**TOWN OF SUMMERVILLE
COMMERCIAL DESIGN REVIEW BOARD – AGENDA
Summerville Municipal Complex
Annex Building 2nd Floor Training Room
June 15, 2017 4:00 p.m.**

**STAFF REPORT
CDRB Meeting
June 15 at 4:00 p.m.**

Site Plan

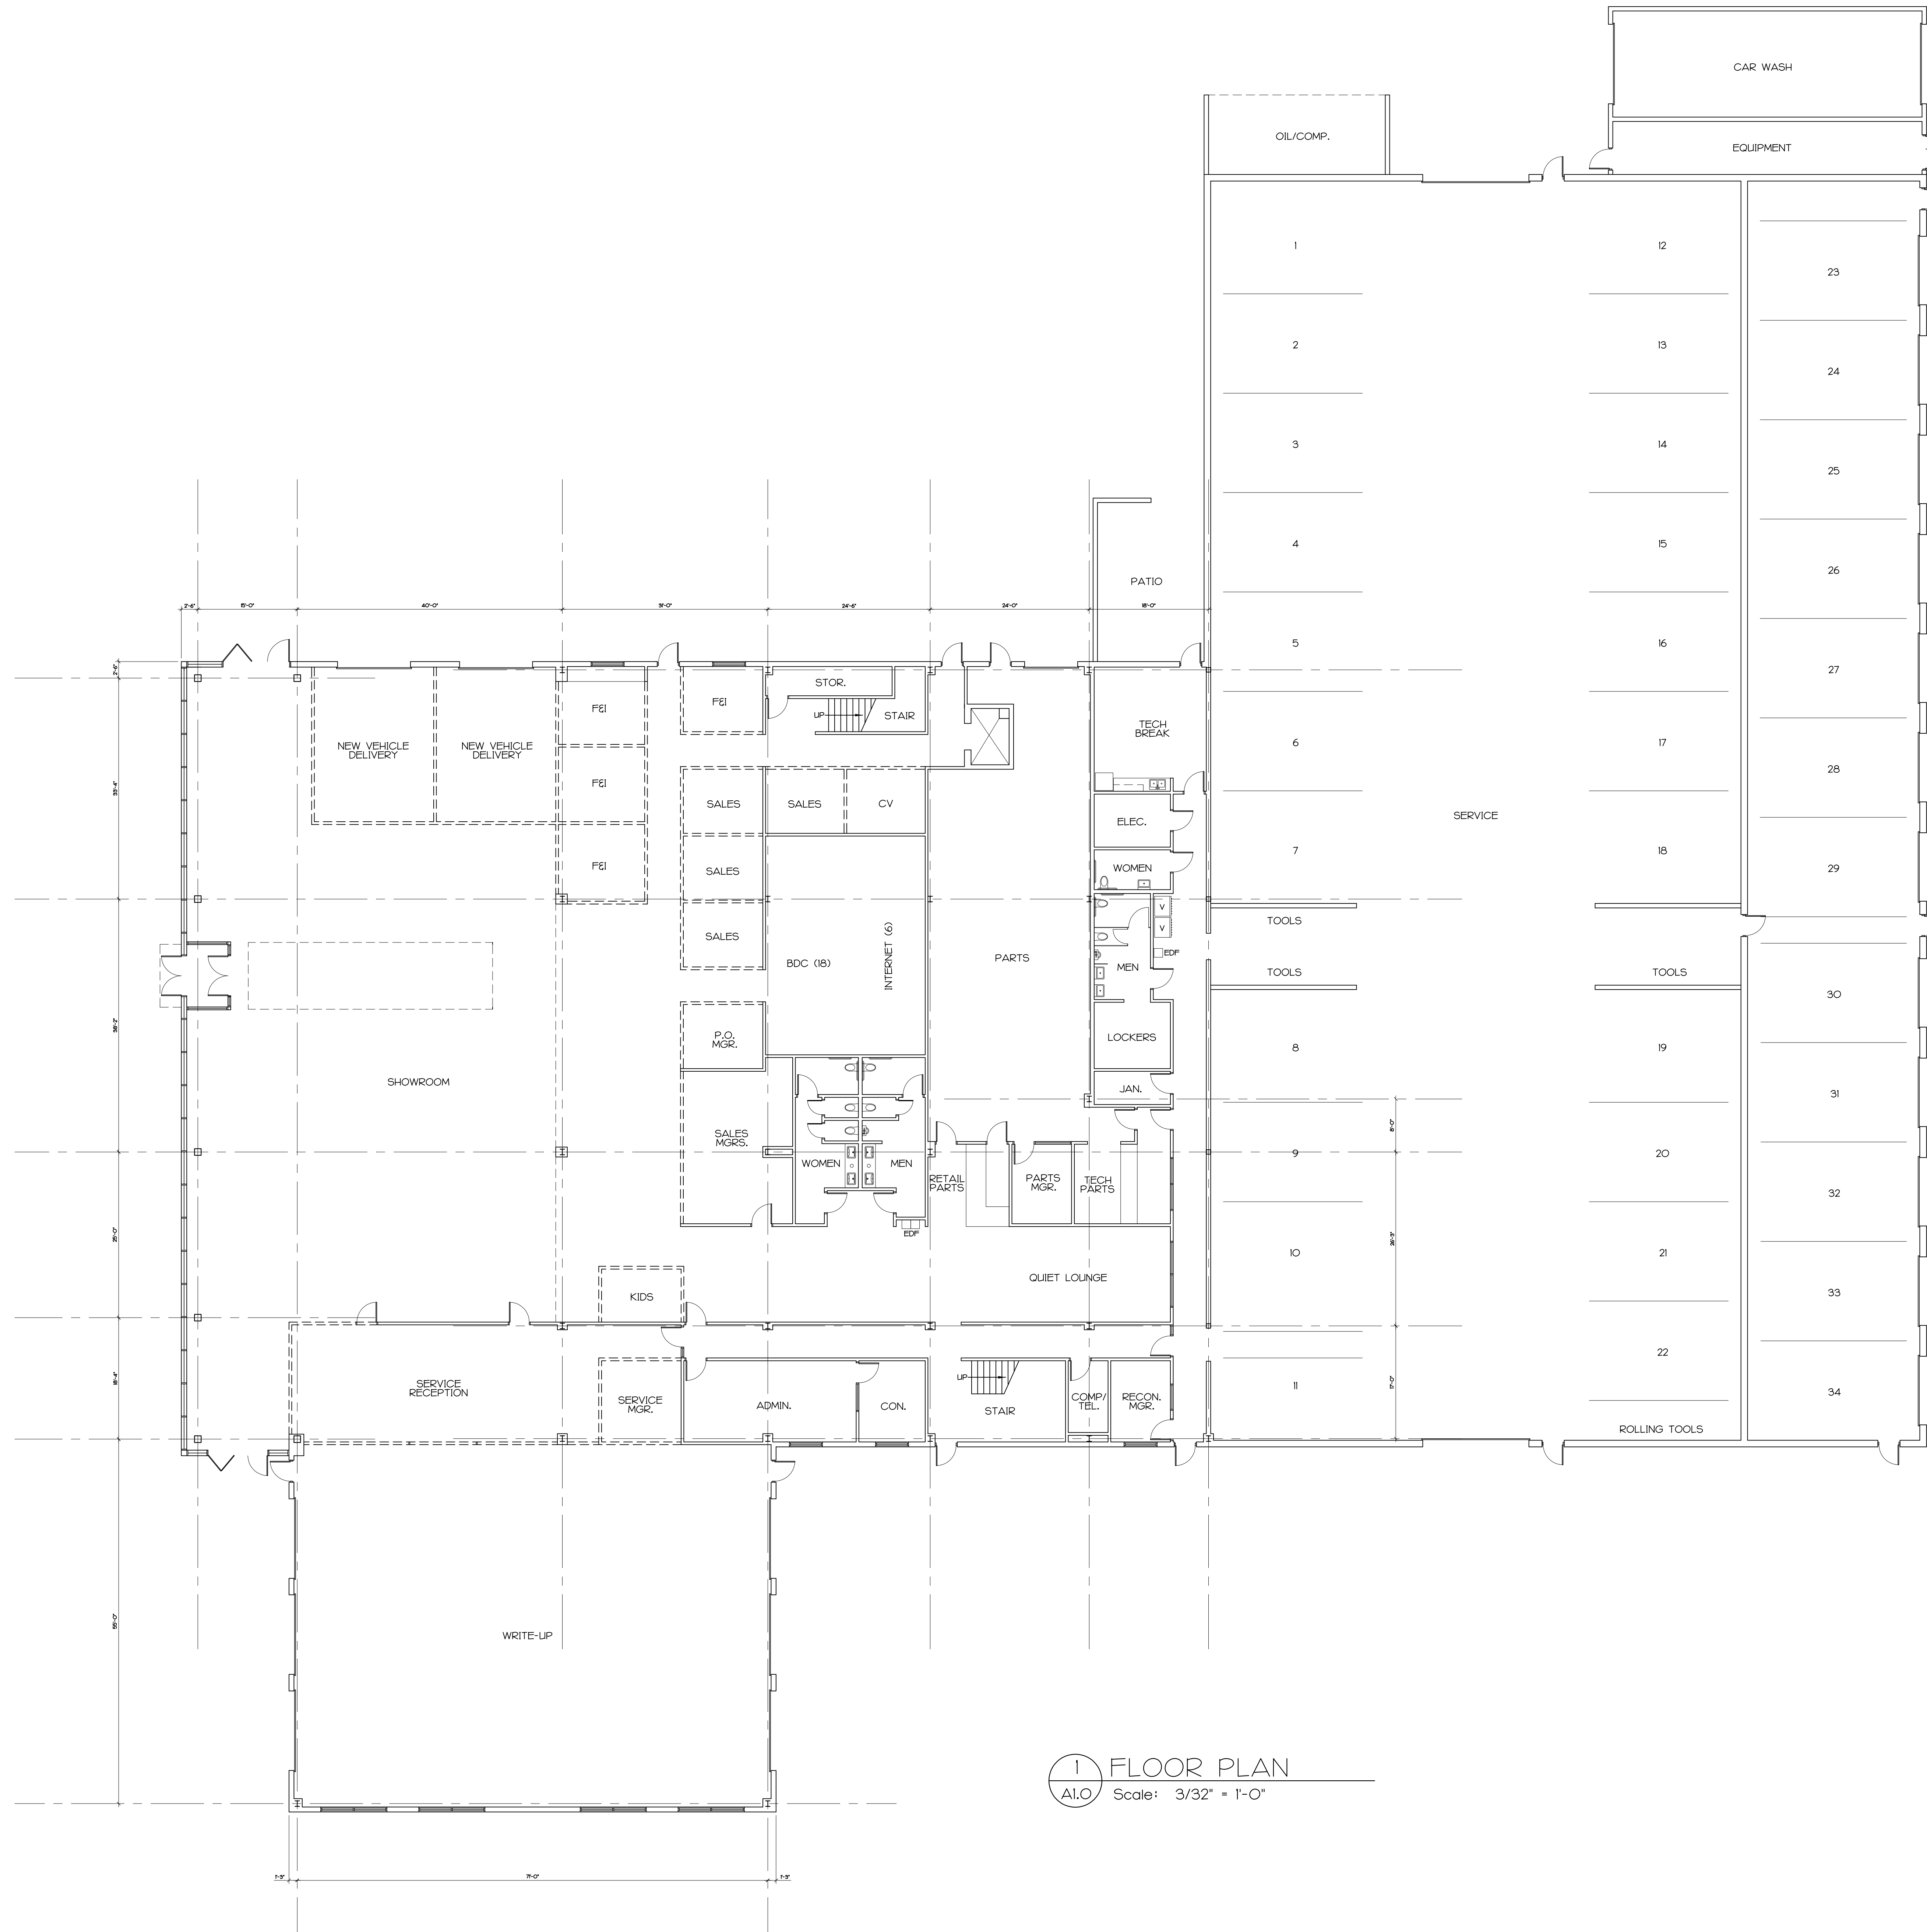
Staff comments are: Cannot clear until all permits are approved. The drainage ditch that is draining onto the property from Interstate 26 needs to be accommodated in the submitted plans. A parking justification letter will be needed.

SITE & LAYOUT PLAN

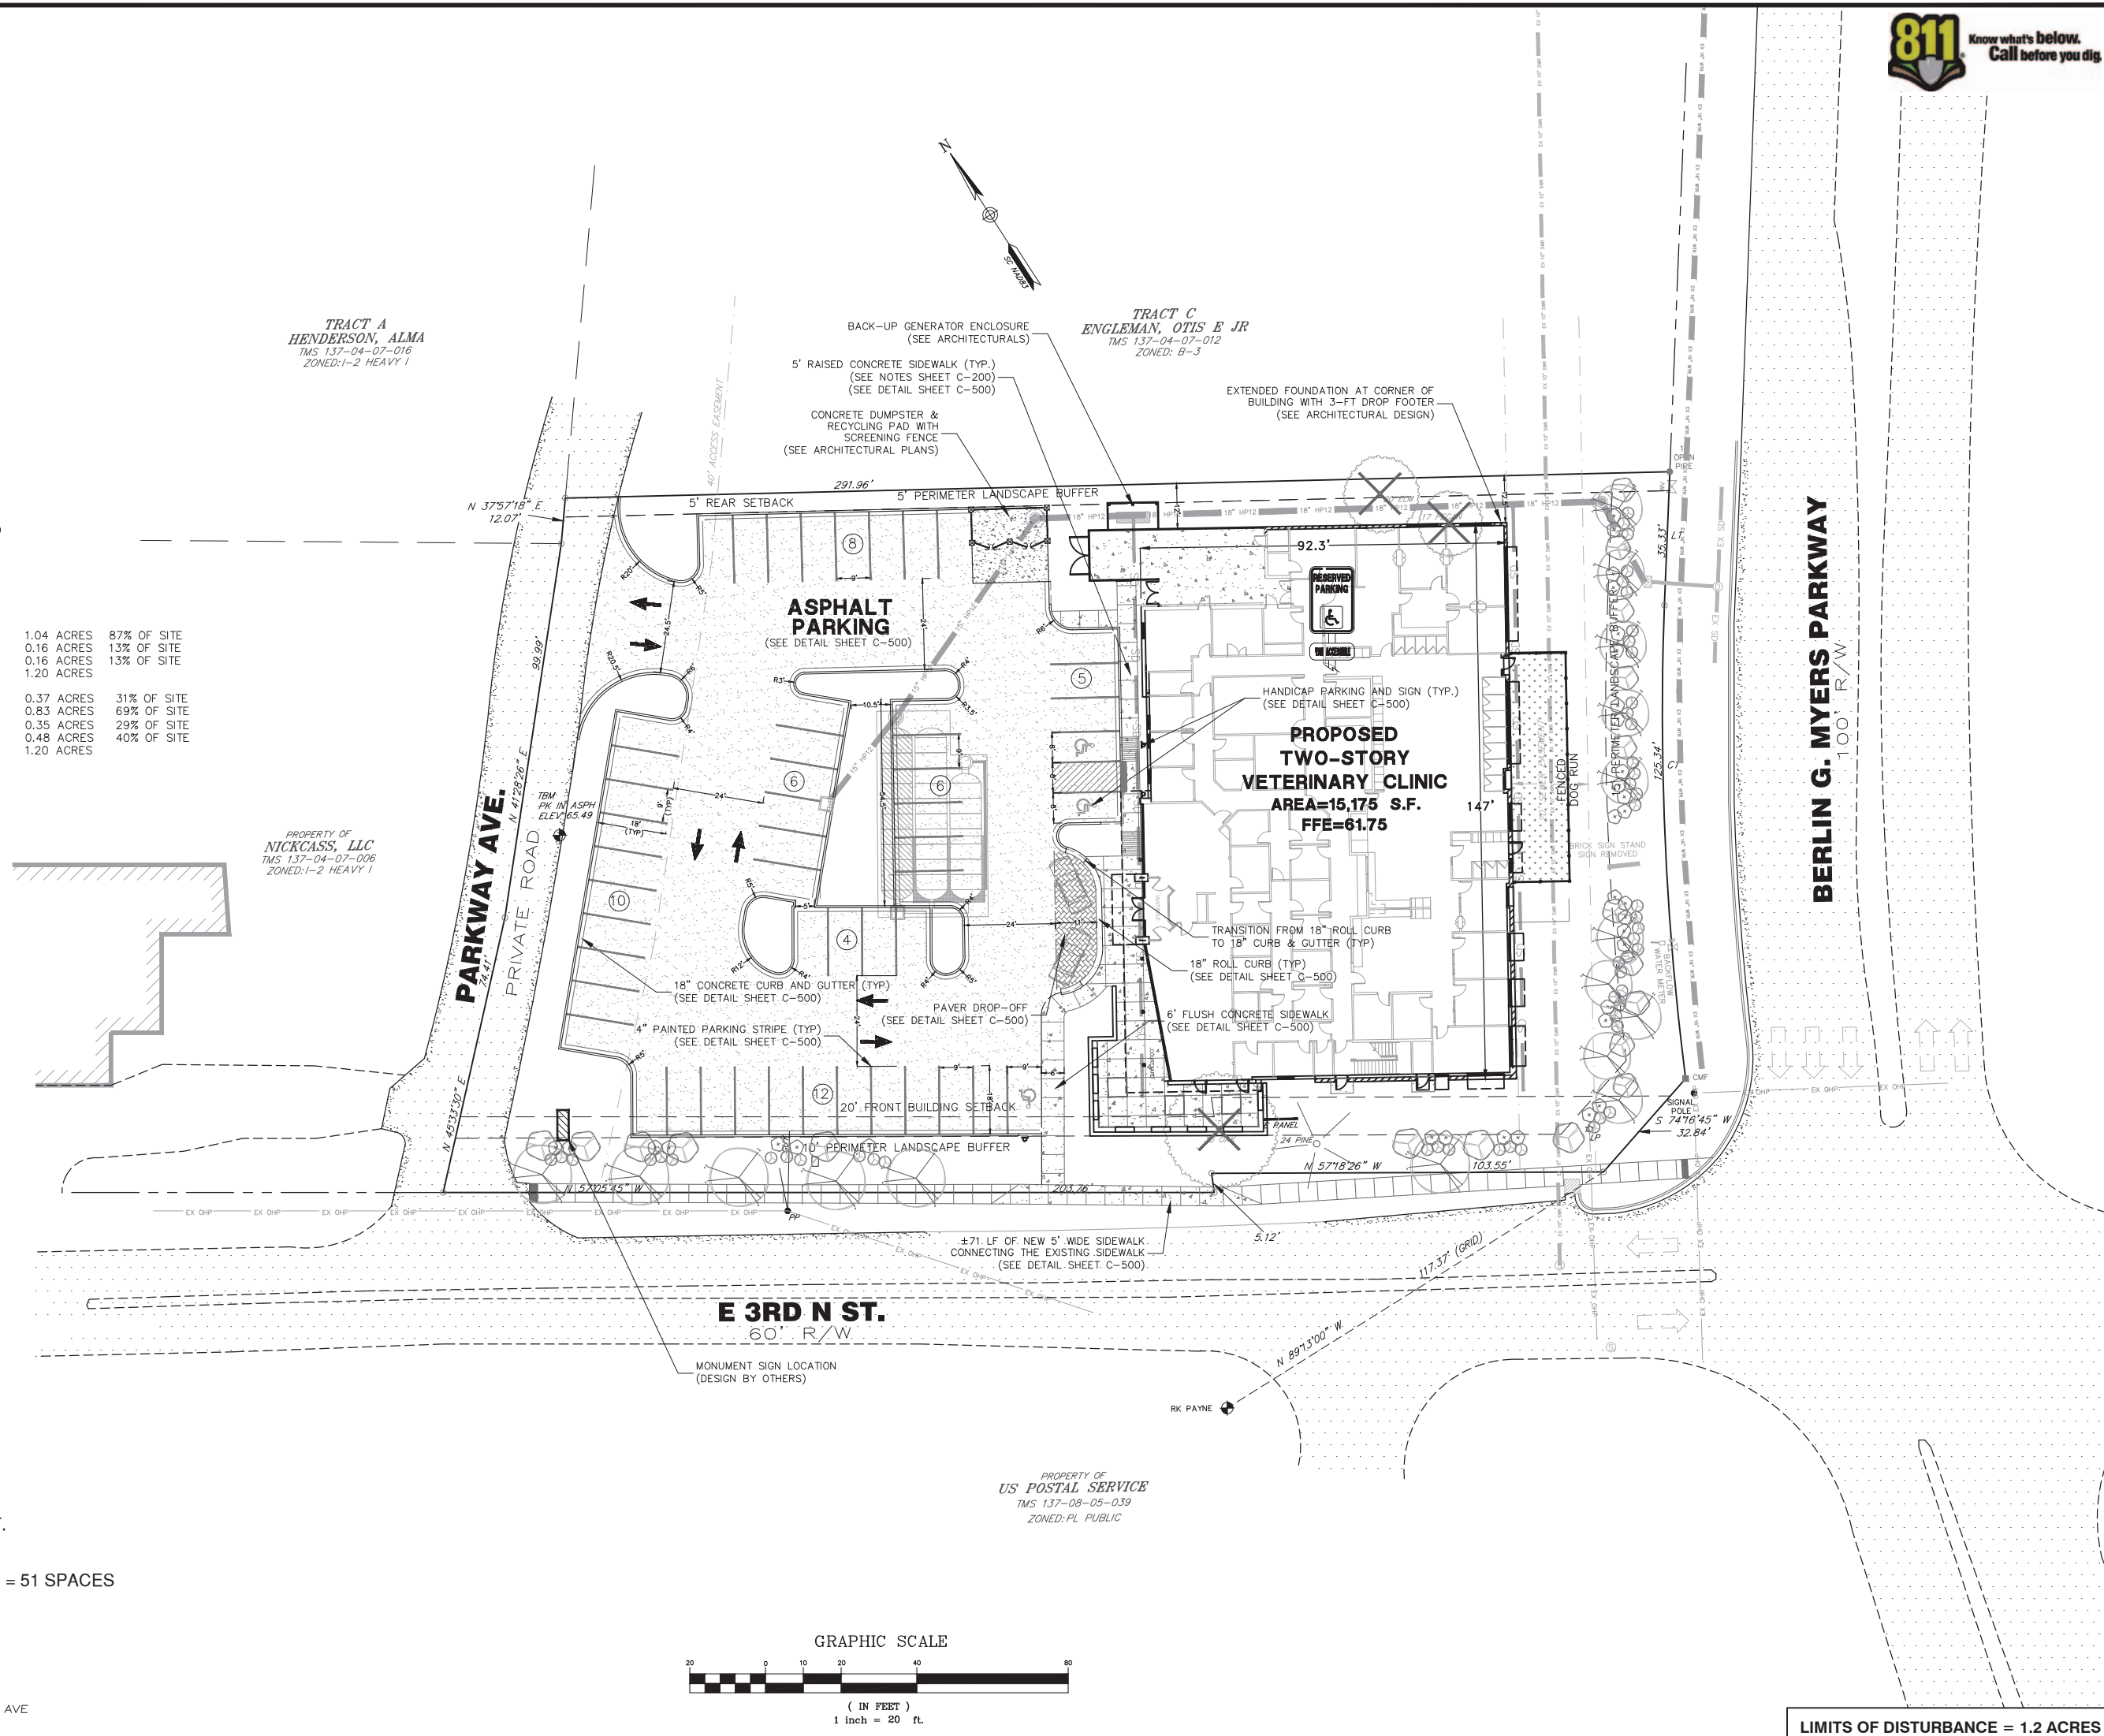
The Town's Engineering Department had the following comments: Staff supports the removal of the driveway on East 3rd North Street. A sidewalk is needed on Berlin G. Myers Parkway side. A dedicated pedestrian easement for the sidewalk is needed since it is on private property along the East 3rd North Street side. A letter is needed from the owner of Parkway Drive allowing the new driveway; Parkway Drive is a private street. Verify with CPW if a dog yard is allowed in their sewer easement. Bicycle parking is not required as this is one of the exempt uses, Veterinary Clinics. Two additional parking spaces are required on site. Location of building to be determined by CDRB, setbacks need to be met. Dumpsters are screened but in the front of the building. Landscaping appears to meet ordinance requirements.
